**AGENDA
CITY OF CEDAR FALLS, IOWA
PLANNING AND ZONING COMMISSION MEETING
WEDNESDAY, JUNE 10, 2020
5:30 PM AT CITY HALL**

- 2. **Downtown Site Plan Review – Community Bank and Trust**
Location: 312 W. 1st Street
Applicant: CB&T – owner; VJ Engineering – Civil Engineer; Emergent Architects
Previous discussion: 3/11/20 (plan deferred; new building design is now proposed)
Recommendation: Discussion and Recommend Approval
P&Z Action: Review and make a recommendation to the City Council

TO: Planning and Zoning Commission
FROM: Karen Howard, Planning & Community Services Manager
DATE: June 3, 2020
SUBJECT: Site Plan Review: 312 W. 1st Street

REQUEST: Request to approve the Site Plan for 312 W. 1st Street (Case #SP19-017)

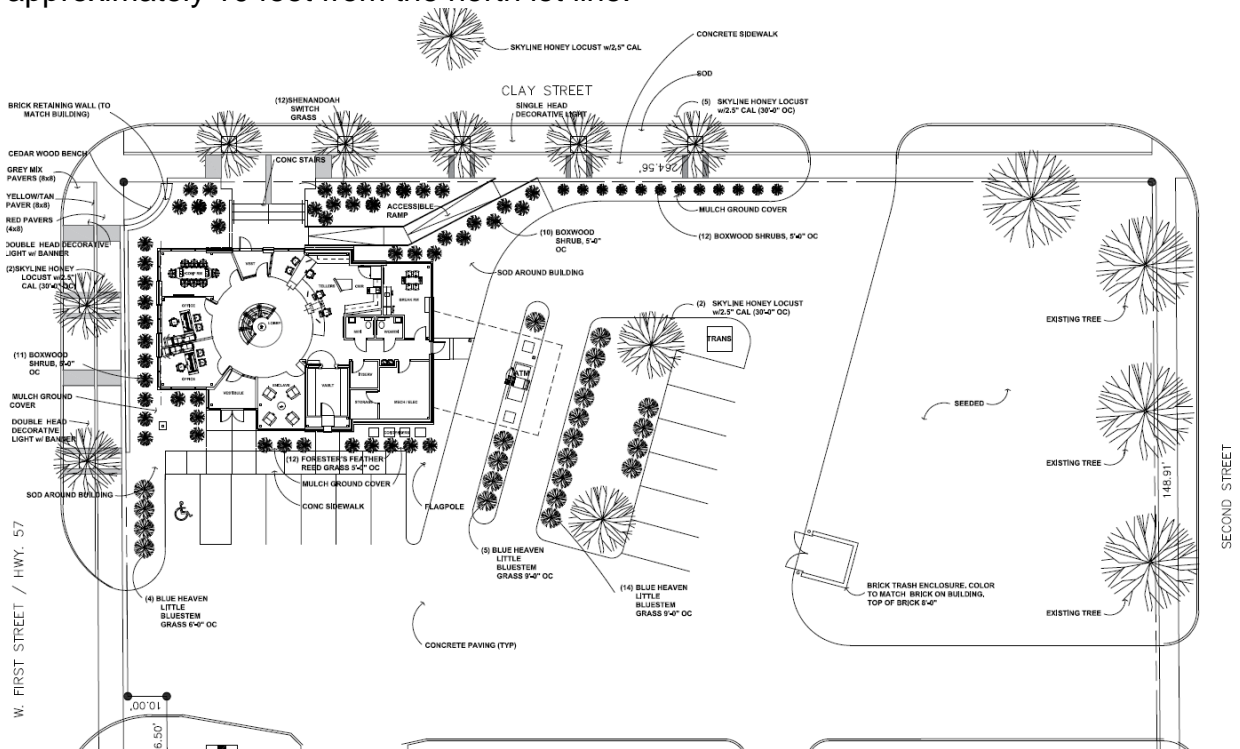
- Approximately 95 feet from the west property line
- 135 feet from the south property line to the edge of the drive through canopy. While this side of the building faces toward 2nd Street, the bank has indicated their intention to make the southern portion of the lot available for additional development. The south side of the bank facility will no longer be visible from 2nd Street when the proposed additional development occurs, so staff considers this a temporary condition, so the south façade is not considered a street-facing façade for purposes of this review.

All setbacks meet the standards, except the maximum setback standard along Clay Street and the temporary situation with the setback from 2nd Street. Staff recommends approval of an exception based on the findings noted above.

LANDSCAPE PLAN

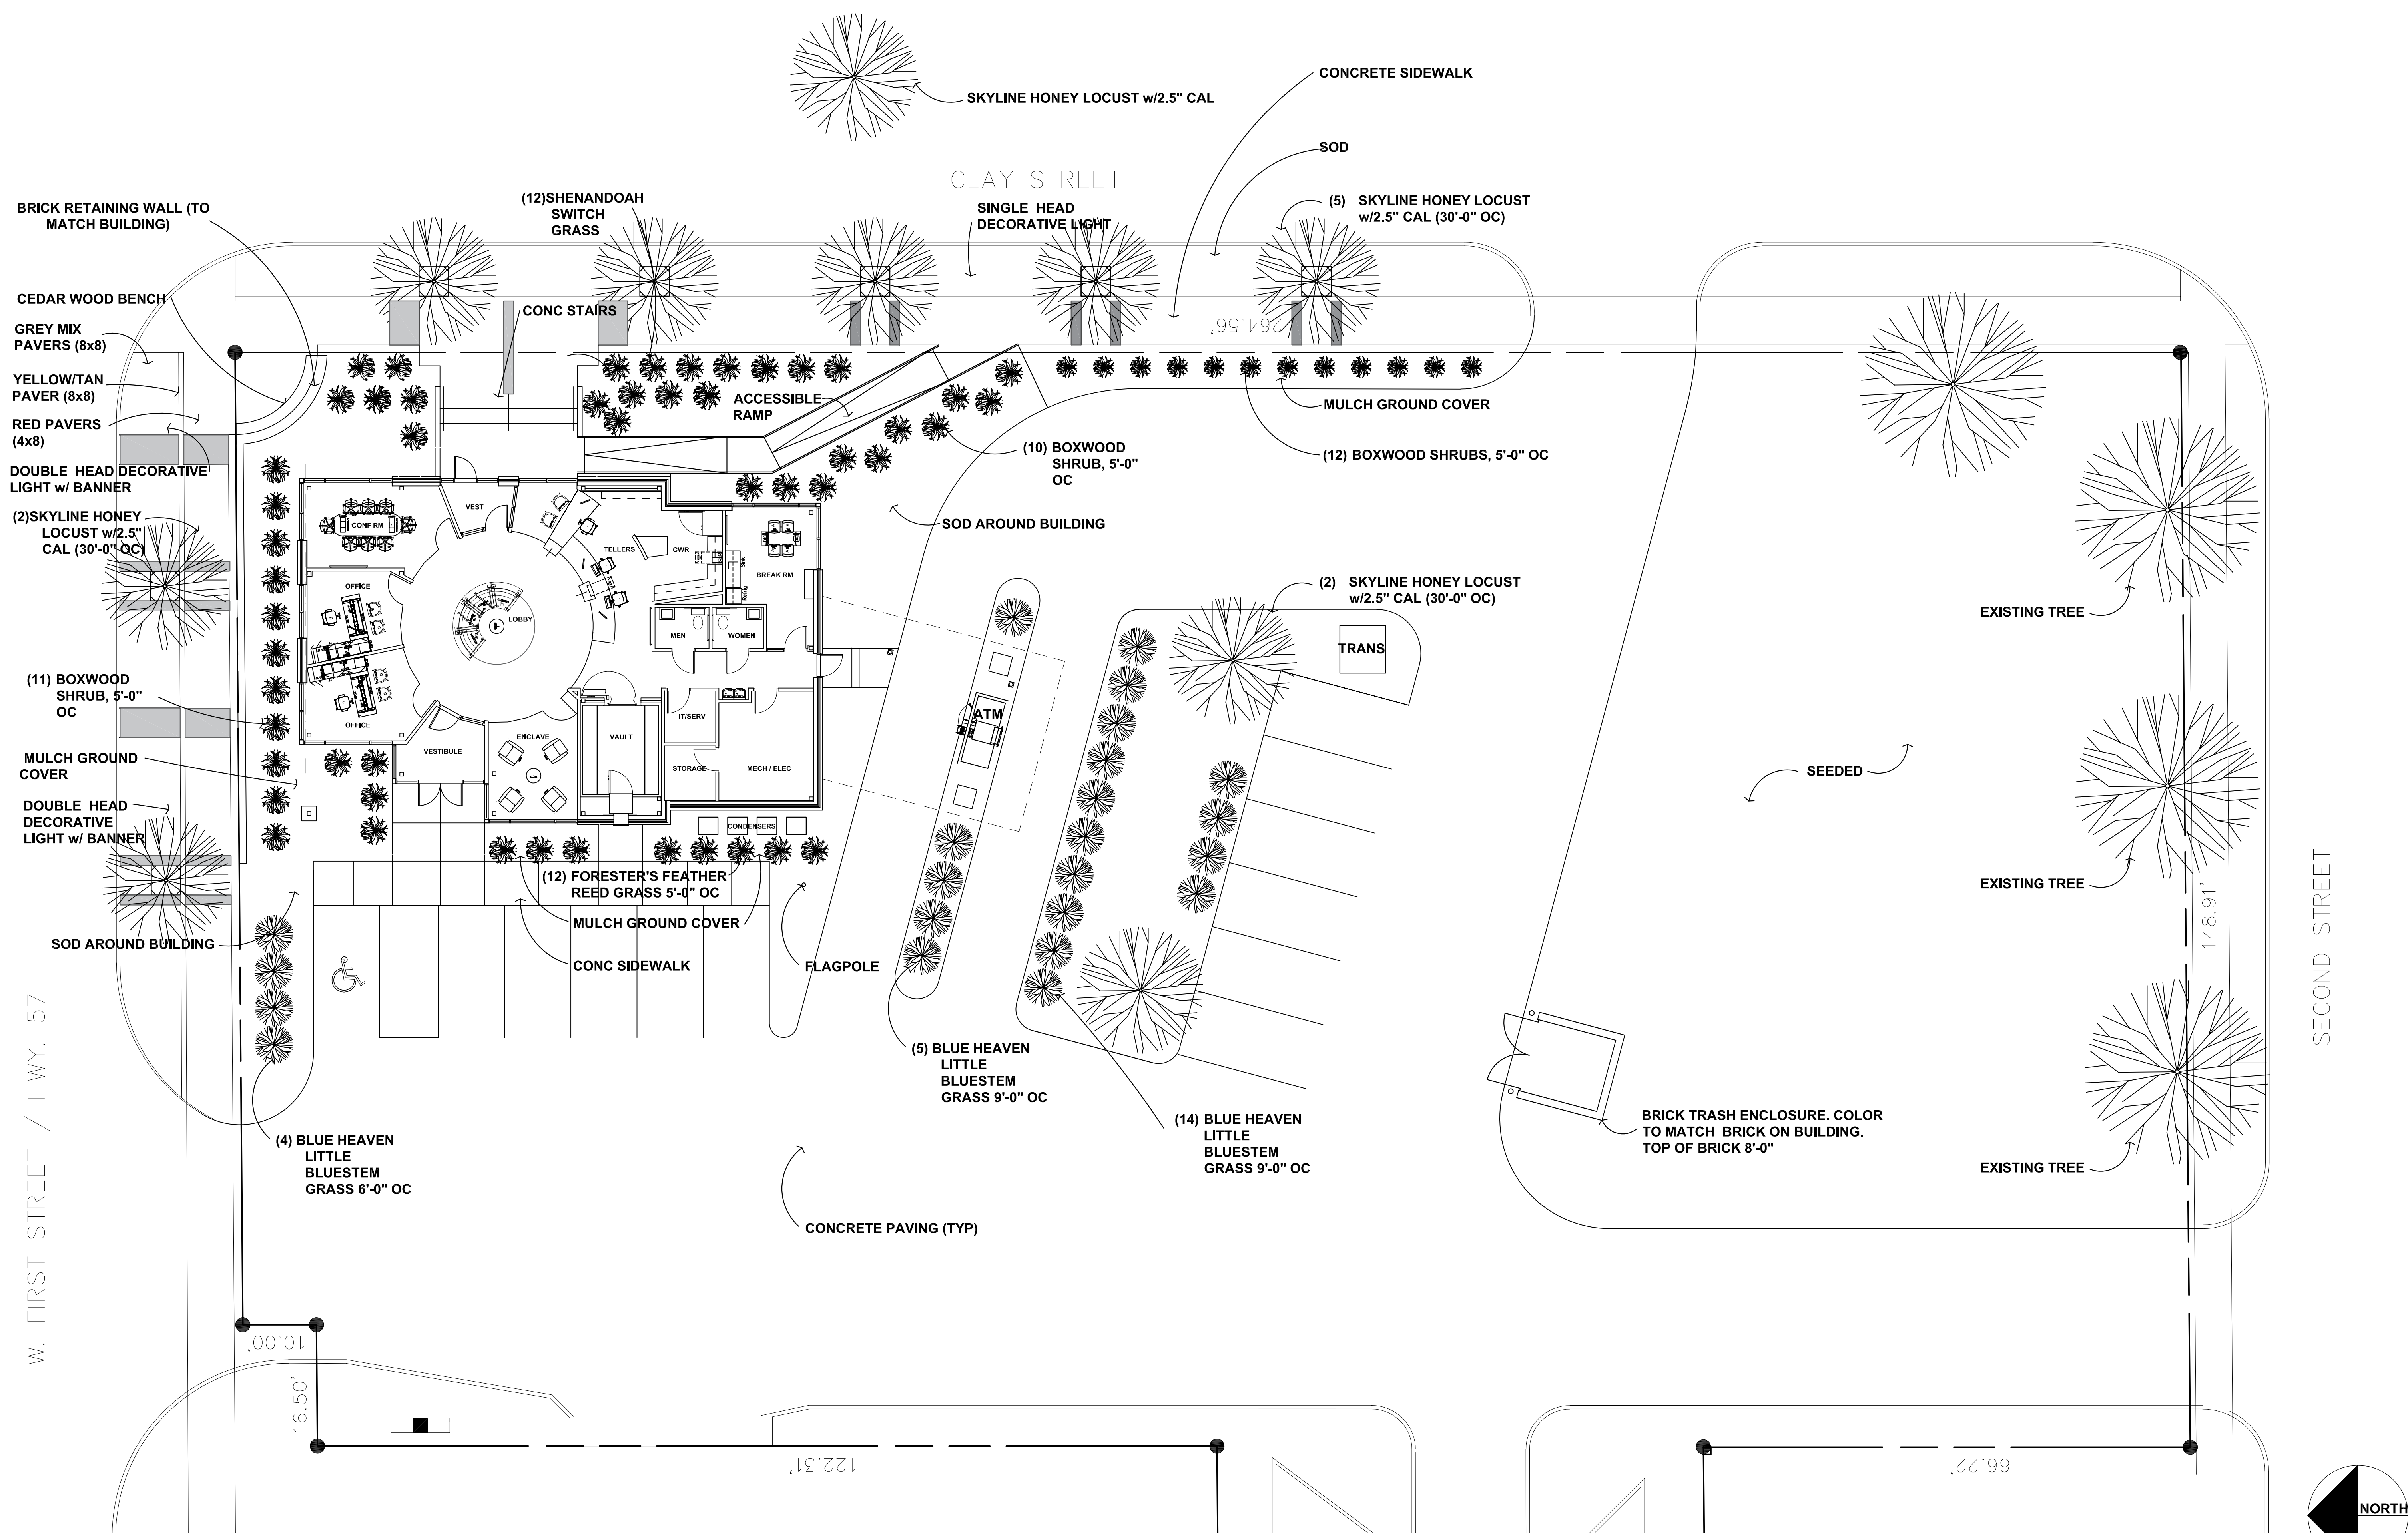
- d) Open Space/Landscaping: There are no open green space requirements in the C-2 Commercial district. However, a parking lot must provide a minimum setback of 5 feet from the public right of way and screen parking areas from view of the public right-of-way. The access lane off the east side of the drive-through canopy is 5 feet from the east lot line and the parking stalls off the west side of the building are approximately 10 feet from the north lot line.

A continuous row of vegetative plantings are needed to screen the parking areas from the adjacent roadways. The landscaping plan shows a row of bluestem grasses along W. 1st Street and boxwood shrubs along Clay Street. Additional plantings are proposed along the west side of the building and the drive-through islands with feather reed grasses and bluestem grasses. There is also an area with switch grasses along Clay Street between the public sidewalk and access ramp to the patio area. Two honey locust trees are planted in the larger landscaped island south of the drive-through. Seven street trees are included in the public sidewalk area as part of the applicant's streetscape plan for this site.

The sidewalk along Clay Street will be constructed of concrete with brick paver inserts, and street trees planted in a landscaped parkway between the sidewalk and the curb. A single-head decorative light will be installed mid-block along Clay Street. The City will work with the developer on the final layout of the brick pavers, sidewalk, and parkway design to be consistent with the Downtown Streetscape Plan. This development is an extension of the streetscape design that will be installed along Main Street and other areas of downtown as redevelopment occurs. It should be noted that decorative streetscape elements will not be installed in the sidewalk area that is south of the driveway on Clay Street at this time. It is anticipated that within approximately two years, there will be additional development proposed in the southern portion of the lot. Rather than install the decorative streetscape elements at this time and risk damage during redevelopment, staff is supportive of postponing installation of the streetscape. A timeline should be established in the development agreement to ensure eventual compliance. **Open Space/Landscaping requirements are satisfied.**

VIEW FROM CLAY STREET

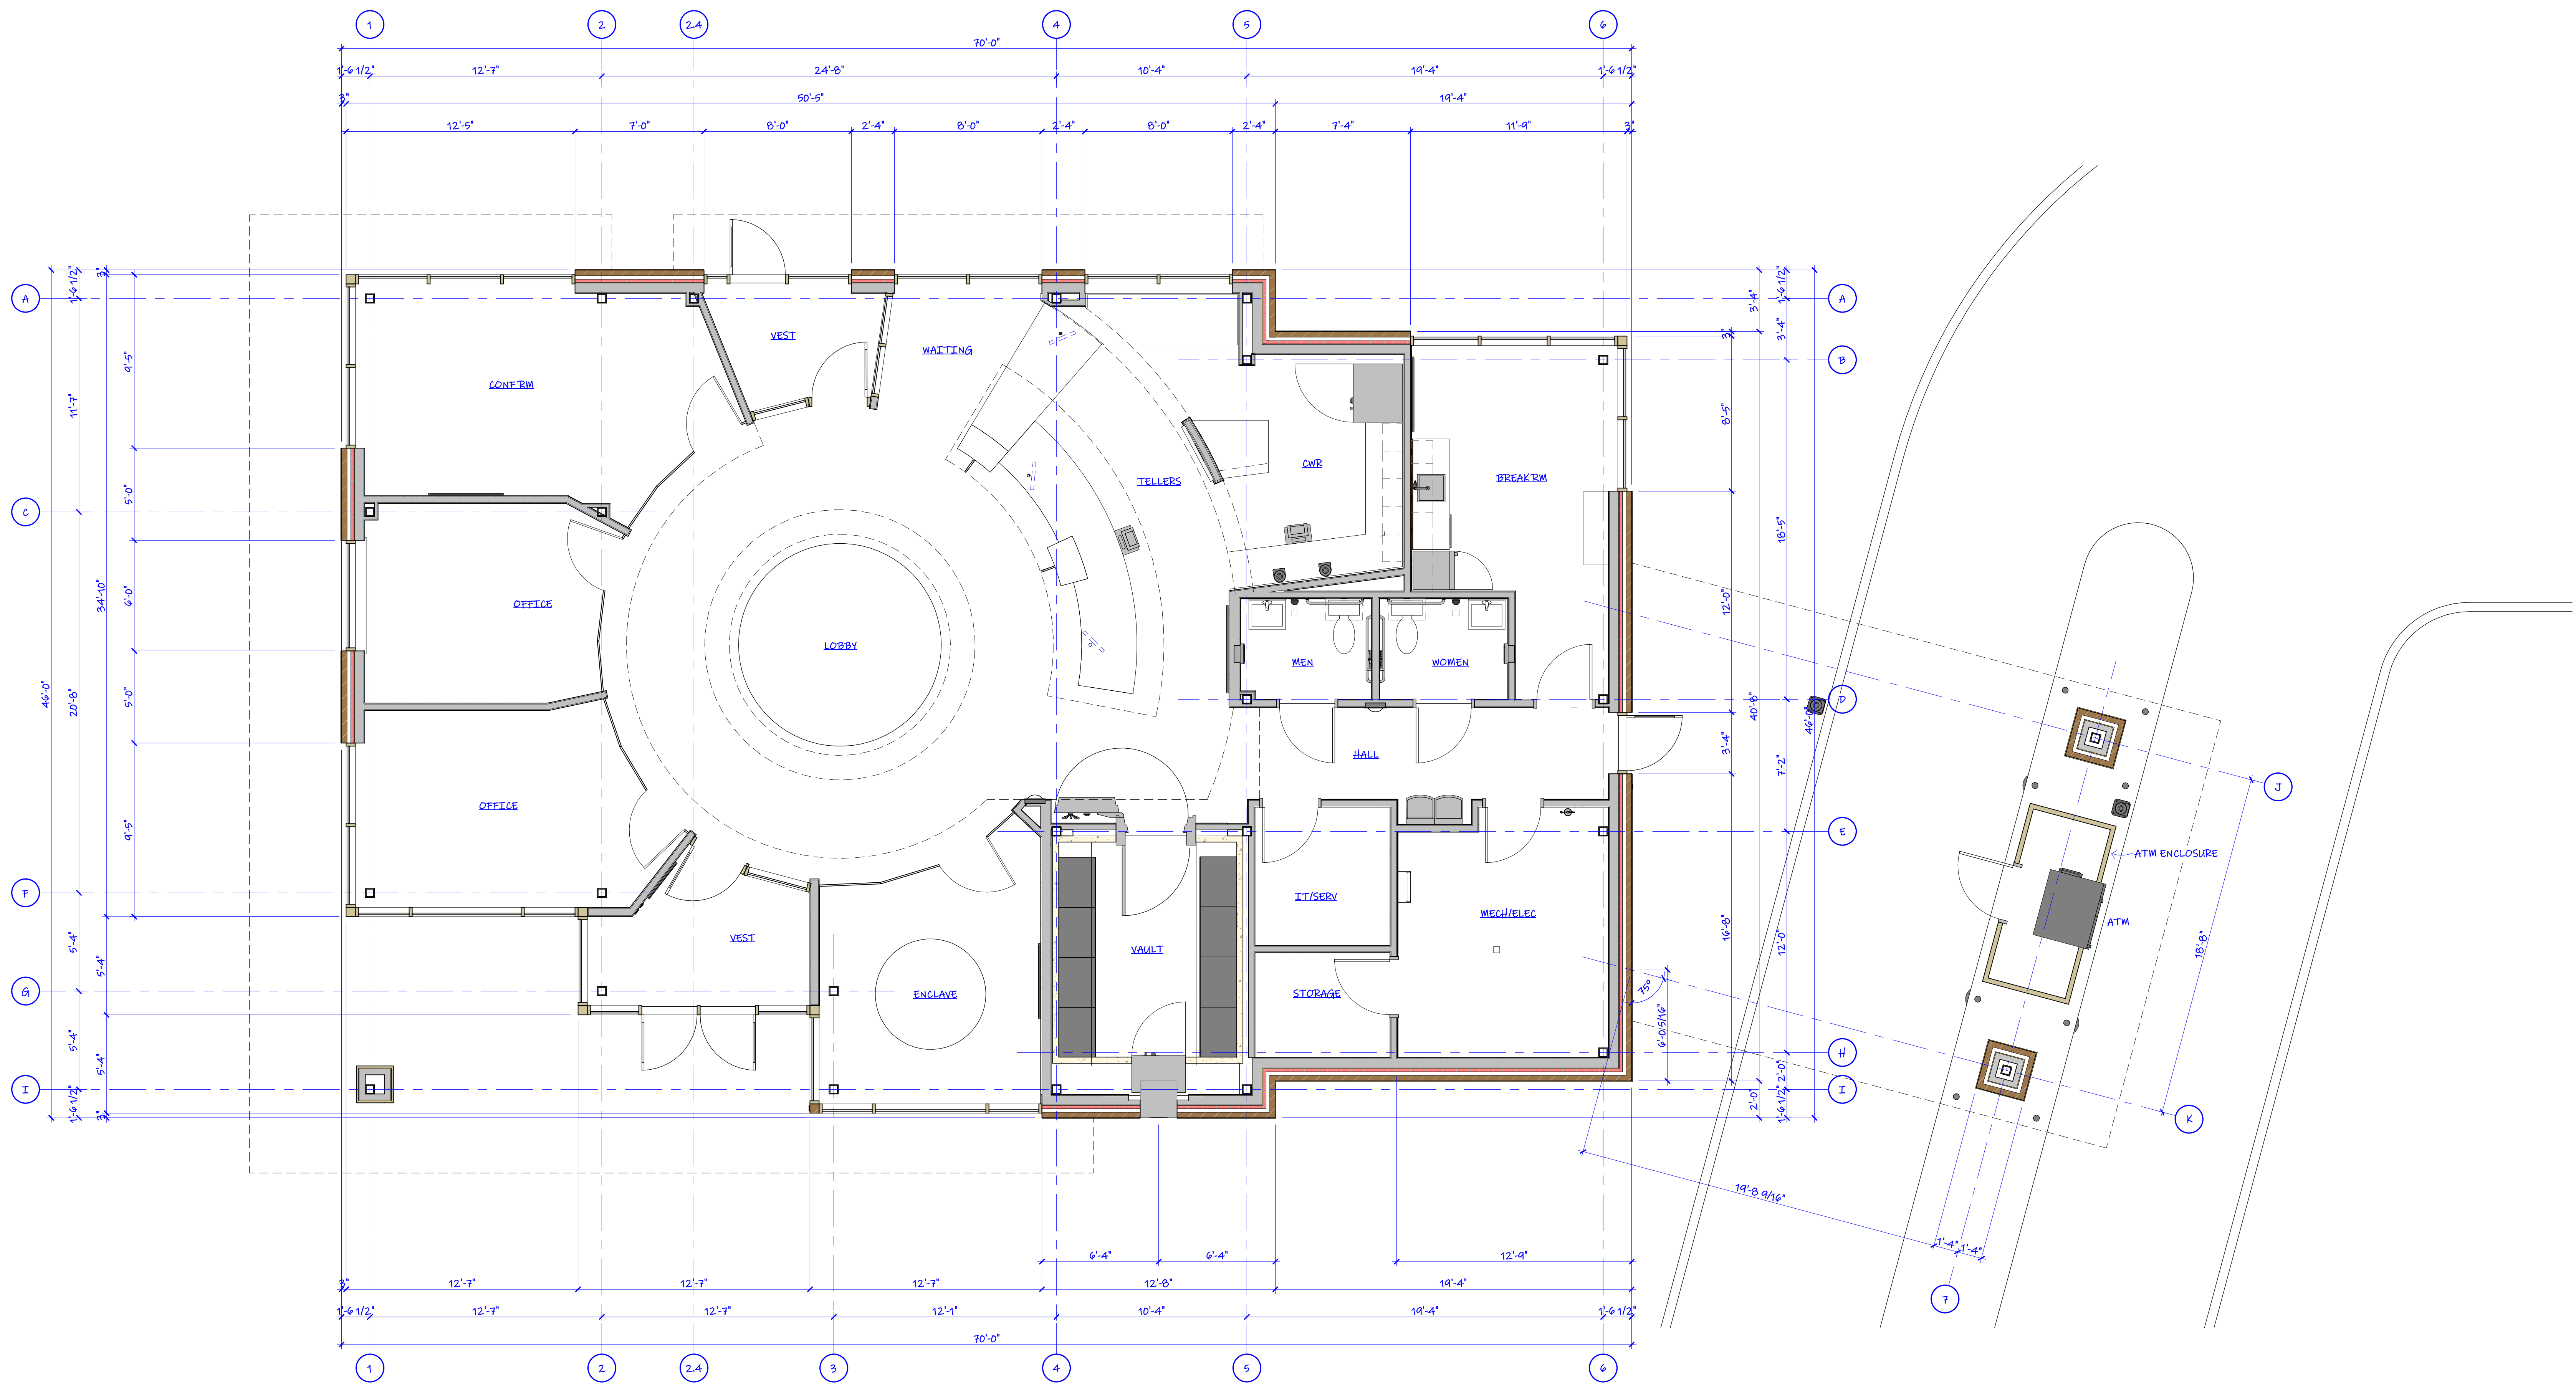
This criterion is established to ensure that the building fits into the context of adjacent structures and to break up the mass and scale of larger buildings. The subject building is only one story tall, so does not create an imposing structure on the site. The standard applies to the street-facing facades. The 1st Street façade is approximately 35 feet wide, so does not need to be divided into modules. The Clay Street façade is approximately 70 feet in length and is divided into three discernible modules based on rhythm of solid surfaces and window groupings: an approximately 20-foot module at the corner with one larger window grouping with three lites, then a 35-foot module with three window openings of equal width with 2 lites each, then a change in plane that creates a third module at the southern end of the façade that is set back about 3 feet from the main façade and includes another large window group with three lites at the southeast corner of the building. **Staff finds that the design meets the building composition standard in the code.**
